Worn
OH-58
Shoes?

a NEW PAIR

Finding serious wear on your Kiowa skid shoes from running landings or extended use?

NEW FULL LENGTH SKID SHOE REPLACES THESE

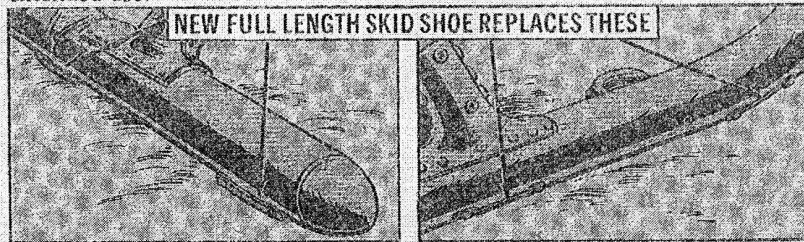
Here's a new full-length skid shoe to replace the 4-inchers your bird came with. Details on making the shoes and fastening methods are in TB 43-0001-2-2 (Jan 77). But experience with the skid shoes since the TB came out has brought up more information and improvements.

FIRST, EACH COUPLER CLAMP SHOULD BE SPOT WELDED TO THE SKID SHOE MATERIAL IN 5 PLACES, NOT JUST 3 LIKE IT SAYS IN THE TB!

SPOT
WELD
5 PLACES

WELD BEAD
ENTIRE LENGTH
OF SHOE

When installing the skid shoes, keep the gap between the front edge of the shoe and the skid surface .10 (1/10) inch or less after the front clamp is tightened.
